City of Lakewood
Board of Building Standards •
Architectural Board of Review •
Sign Review Board

MINUTES
BOARD OF BUILDING STANDARDS/
ARCHITECTURAL BOARD OF REVIEW/SIGN REVIEW
REVIEW MEETING
CITY OF LAKEWOOD
12650 DETROIT AVENUE
AUDITORIUM
NOVEMBER 13, 2025
5:30 P.M.
MEETING RECORDED

Issue for Sign Review	Sheet
Date 11/11/2025	S4
Drawn By CJM

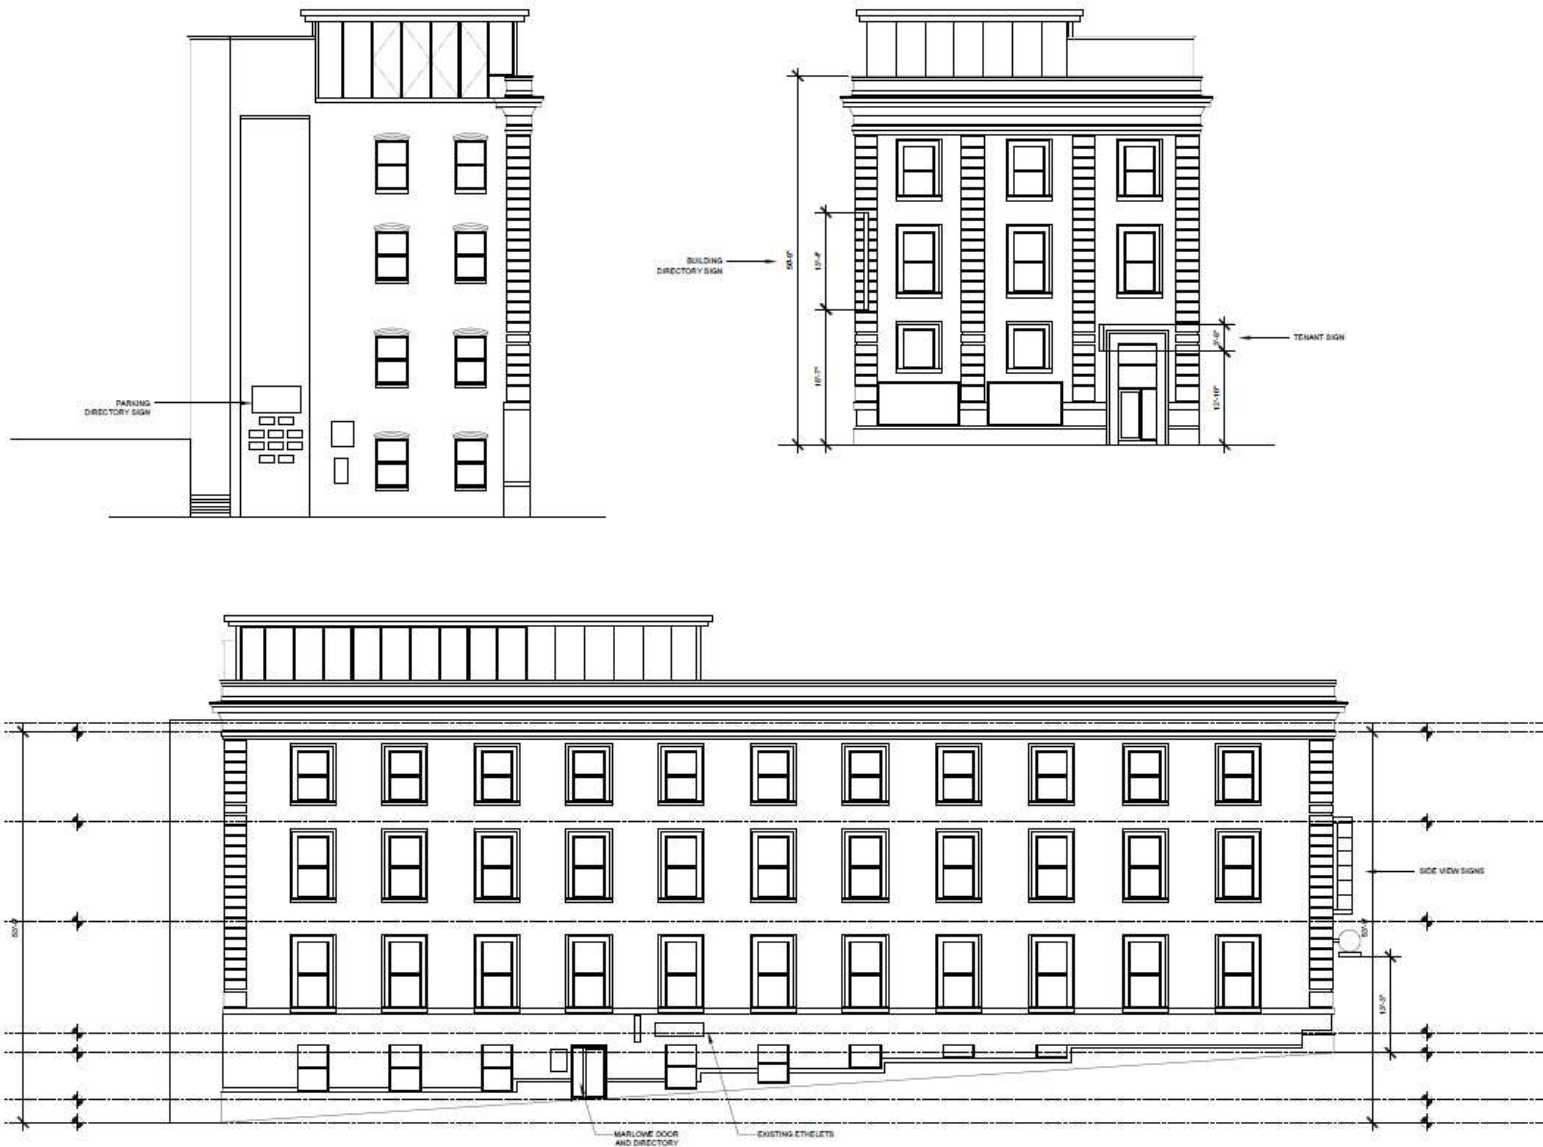
David J. Maniet AIA, Maniet Architects, applicant was present to explain the request. Discussion began about the Ethlete window graphic, the location of the Maverick Financial blade sign, and the advantage of a Comprehensive Sign Plan. Public comment was closed as no one addressed the item. Staff reminded the applicant that tenant sign changes should be reviewed by administrative team before installation.

- Ethlete window graphics are removed
- Maverick Financial blade sign will be in the location as shown on drawing S4.
- Applicant will send staff a clean set of drawings with updates as discussed.

PLANS & DETAILS THIS PAGE.
PROPOSED ELEVATIONS

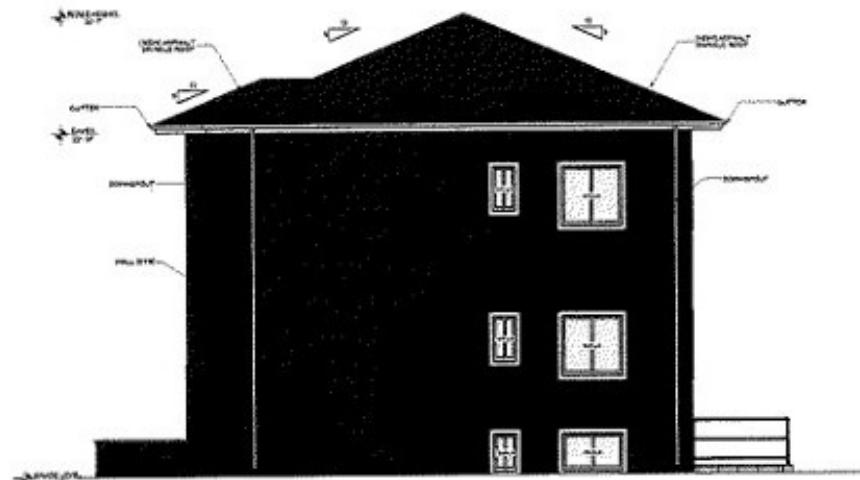
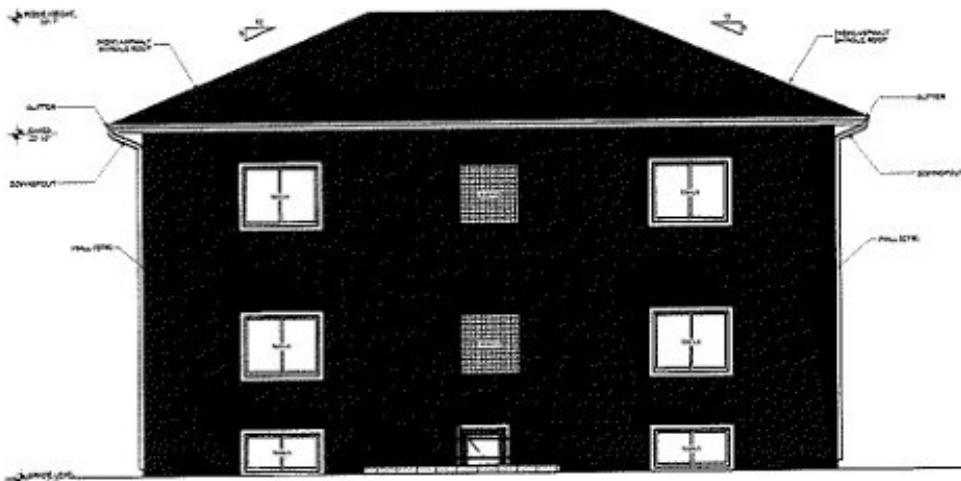
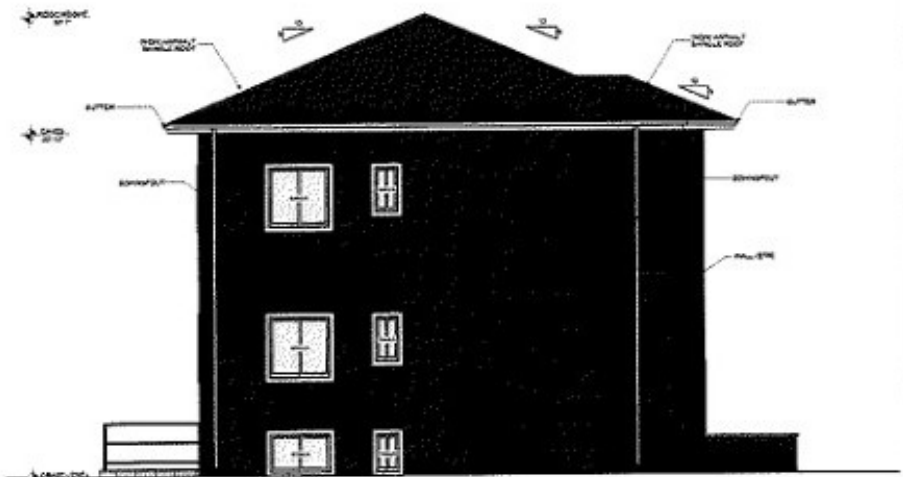
Robert Potocar, property owner, applicant, and Shane Brennan, property owner, were present to explain the project. The members stated the hip roof, and the removal of the awnings would help remediate the water infiltration problem. Public comment was taken. Neither staff nor members had additional comments or questions.

- **Docket 11-99-25: 1375 Lakewood Ave.**
 - The proposal seems reasonable; however the submitted drawings are not legible and it is difficult to comment on. For example, are the window awnings being removed.

- Remove the awnings.
- Bring back to ABR if preference is to keep awnings.

Safran Studio Job # 2025 - 18	Sheet
Sheet Contents Parking Lot Site Plan	S-p2
Scale approx. Scale 1" = 20'-0"

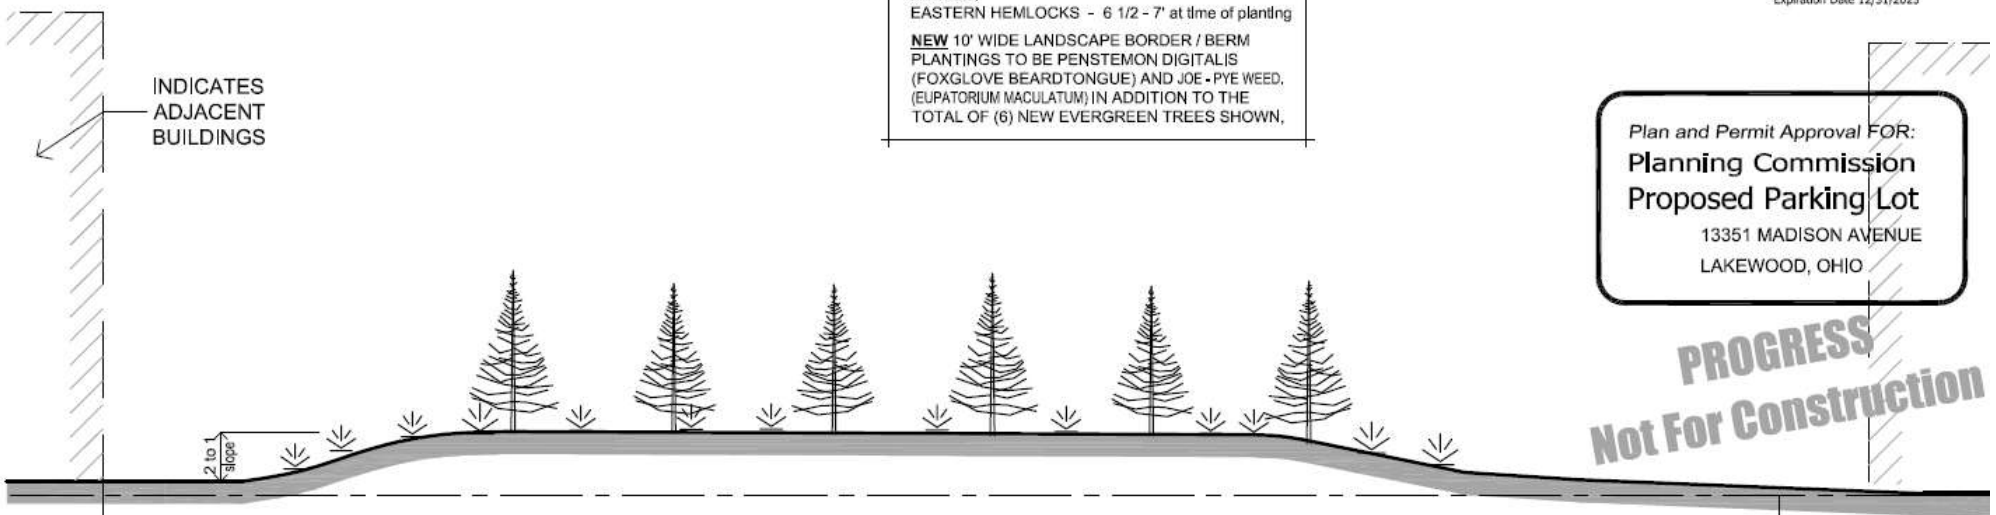
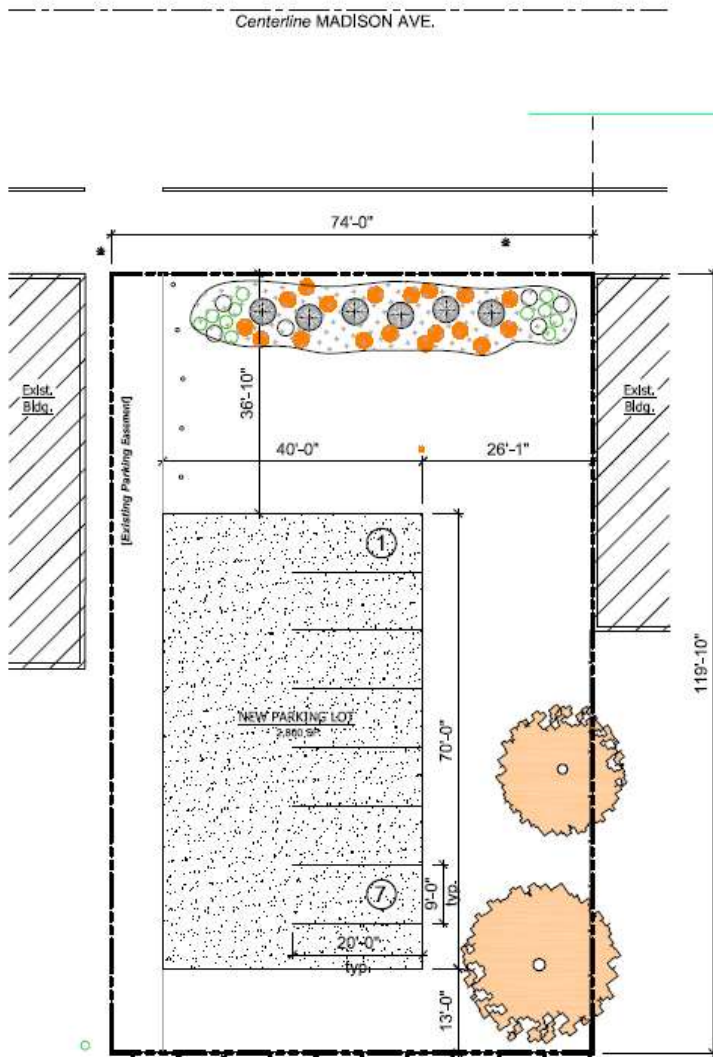
On the site plan, we need to know what the drive aisle width is.

- This parking lot will be accessed partially via the adjacent property to the west. The plan notes an easement. Has this been recorded?
 - Can the paved area be increased slightly (+/-2') to provide 8 full spaces?

- Will any lighting be provided to provide illumination of the parking spaces and drive aisle.
 - We appreciate the landscaping berm. However, review should be given to sightlines to ensure visibility is maintained by drivers to the sidewalk and to oncoming Madison traffic. but is it possible to pull the parking toward the north to gain another full space? Lose the partial space on the south end to offset.

The existing driveway easement will be used as the drive aisle, and it is 13 ft, 6 in. wide. If we can get that added to the drawing in time, I will send an updated drawing.
